## United States Patent and Trademark Office

APPLICATION NO.		FILING DATE	FIRST NAMED INVENTOR	ATTORNEY DOCKET NO.	CONFIRMATION NO.
10/810,672	03/29/2004		Masamichi Fujito	XA-10065	1157
181	7590	05/09/2006	EXAMINER		INER
		BRIDGE PC	PHAN, TRONG Q		
1751 PINN SUITE 500	1751 PINNACLE DRIVE SUITE 500				PAPER NUMBER
MCLEAN,	VA 221	02-3833	2827		
				DATE MAILED: 05/09/200	6

/				
	Application No.	Applicant(s)				
	10/810,672	FUJITO ET AL.				
Office Action Summary	Examiner	Art Unit				
	TRONG PHAN	2827				
The MAILING DATE of this communication appears on the cover sheet with the correspondence address Period for Reply						
A SHORTENED STATUTORY PERIOD FOR REPLY IS SET TO EXPIRE 2 MONTH(S) OR THIRTY (30) DAYS, WHICHEVER IS LONGER, FROM THE MAILING DATE OF THIS COMMUNICATION.  - Extensions of time may be available under the provisions of 37 CFR 1.136(a). In no event, however, may a reply be timely filed after SIX (6) MONTHS from the mailing date of this communication.  - If NO period for reply is specified above, the maximum statutory period will apply and will expire SIX (6) MONTHS from the mailing date of this communication.  - Failure to reply within the set or extended period fo

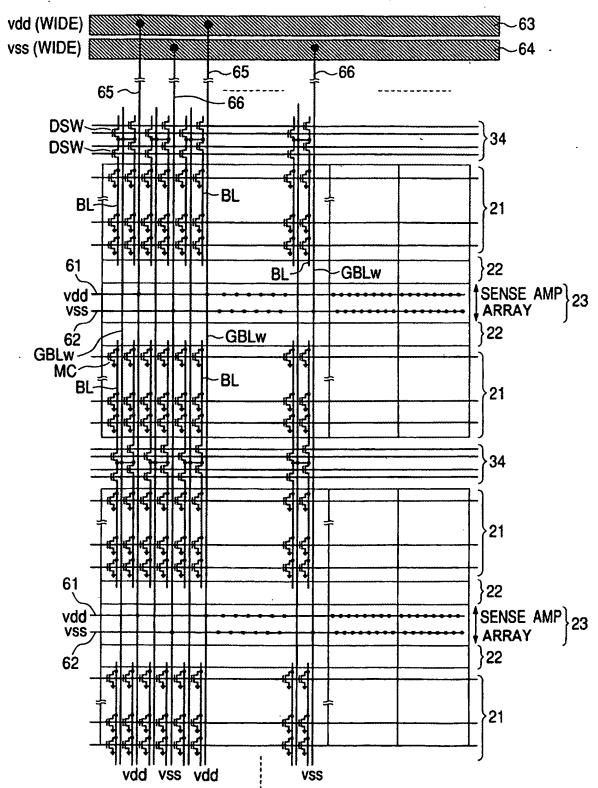
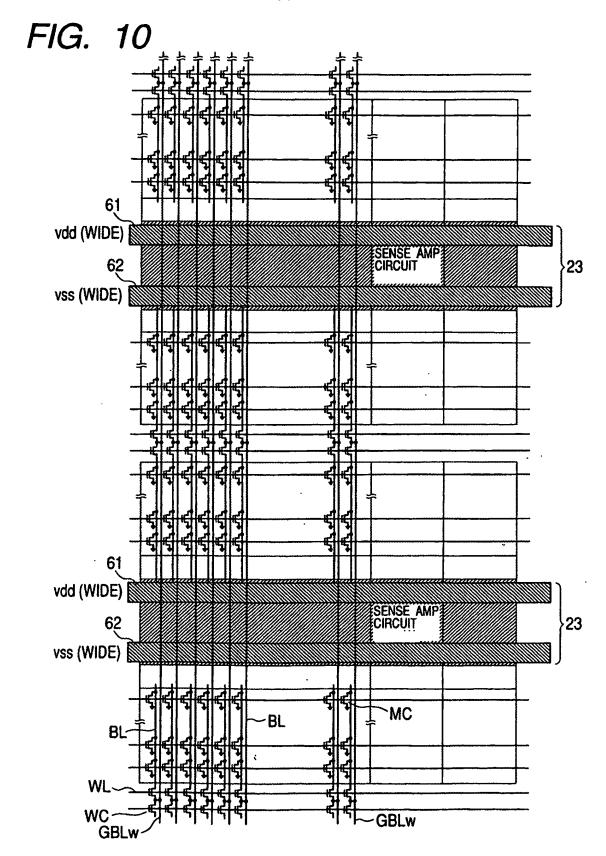
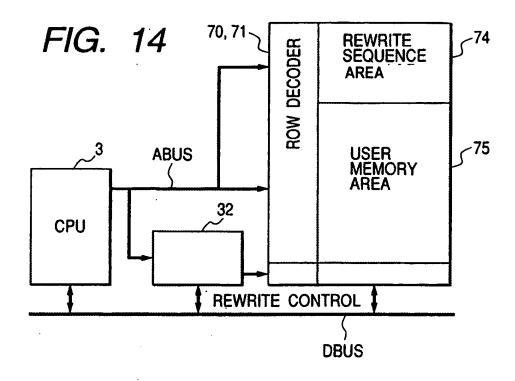
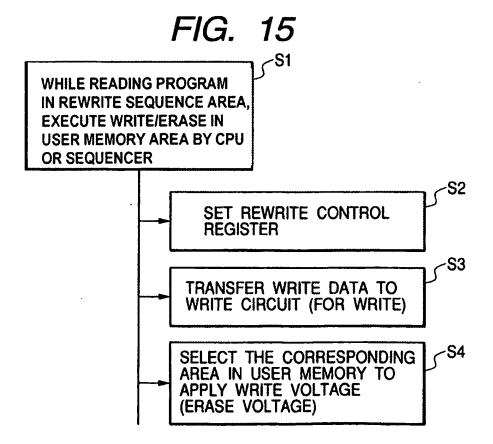
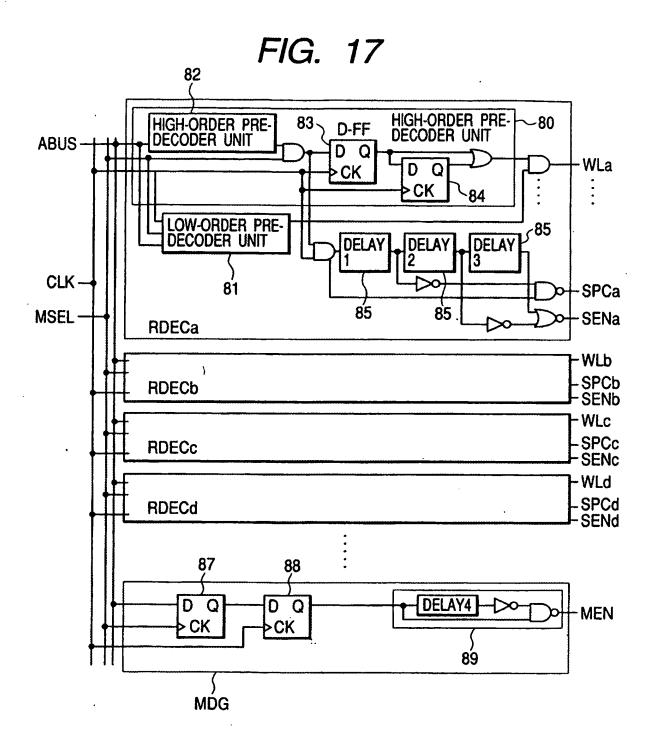
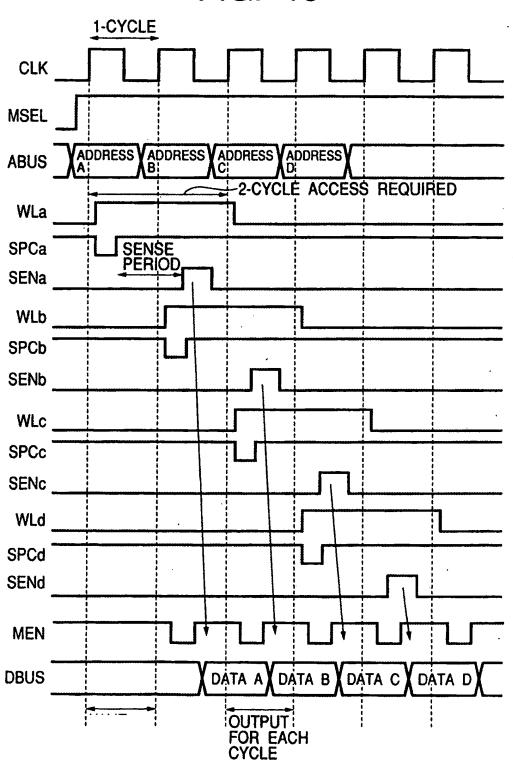
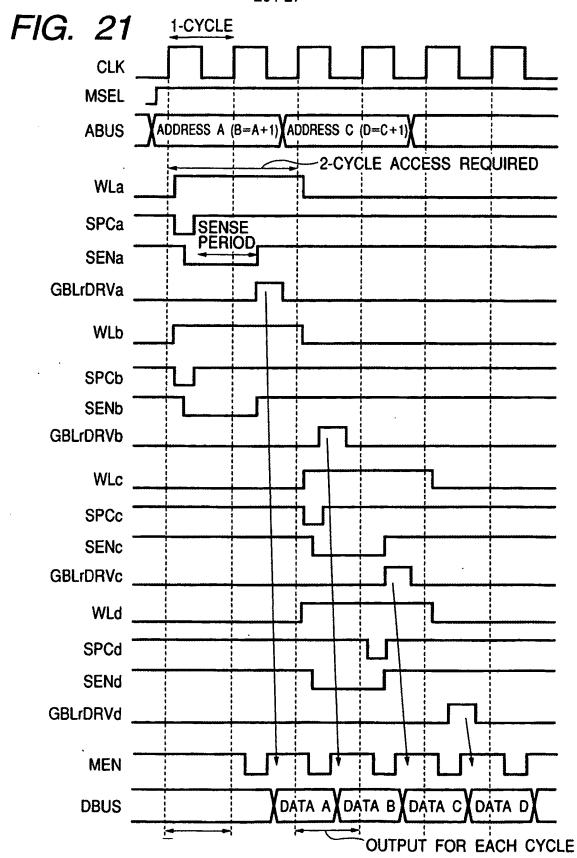
1. The drawings are objected to as failing to comply with 37 CFR 1.84(p)(5) because they include the following reference character(s) not mentioned in the description: 41, n+, n-, p+, p- and p-Sub in Fig. 3; CBL, TRG, SPC(L), SPC(R), SEN(L), SEN(R), SA(L) and SA(R) in Fig. 5; SPC(L), SPC(R), SEN(L) and SEN(R) in Fig. 6); SPC(L) <READ>, SPC(R) <REFERENCE>, CCS <COMPARISON CURRENT SELECTION>, CCS(T), CBL(B) < REFERENCE>, CBL(T) < READ>, SEN(L) < READ>, SEN(R) < REFERENCE >, GBLr(R) < REFERENCE > and GBLr(L) < READ > in Fig. 7; SPC(L), SPC(R), SEN(L), SEN(R), SA(L) and SA(R) in Fig. 8; WL (WRITE), GBLw (WRITE), WL (READ) and GBLr (READ) in Fig. 12; SA(L), SA(R), WLa, WLb, WLc, WLd, SPCa, SPCb, SPCc, SPCd, SENa, SENb, SENc and SENd in Fig. 16; WLa, WLb, WLc, WLd, SPCa, SPCb, SPCc, SPCd, SENa, SENb, SENc and SENd in Figs. 17-18; GBLrDRVc, GBLrDRVd, SA(L), SA(R), WLa, WLb, WLc, WLd, SPCa, SPCb, SPCc, SPCd, SENa, SENb, SENc and SENd in Fig. 19; RDECab in Fig. 20; SPC (L), CCS (T), CBL (T), CBL (B), CCB, CCS (B), SEN (L) and SA(L) in Fig. 22; SA (L), GBLv [VERIFY GBL] and GBLr [READ GBL] in Figs. 25 and 27; CMP (VERIFY COMPARATOR) in Fig. 28; CBL (T), CBL (B), CCB, CCS (B), SPC (L), CCS (T), CCS (B), [READ GBL] and [VERIFY GBL] in Fig. 29. Corrected drawing sheets in compliance with 37 CFR 1.121(d), or amendment to the specification to add the reference character(s) in the description in compliance with 37 CFR 1.121(b) are required in reply to the Office action to avoid abandonment of the application. Any

amended replacement drawing sheet should include all of the figures appearing on the immediate prior version of the sheet, even if only one figure is being amended. Each drawing sheet submitted after the filing date of an application must be labeled in the top margin as either "Replacement Sheet" or "New Sheet" pursuant to 37 CFR 1.121(d). If the changes are not accepted by the examiner, the applicant will be notified and informed of any required corrective action in the next Office action. The objection to the drawings will not be held in abeyance.
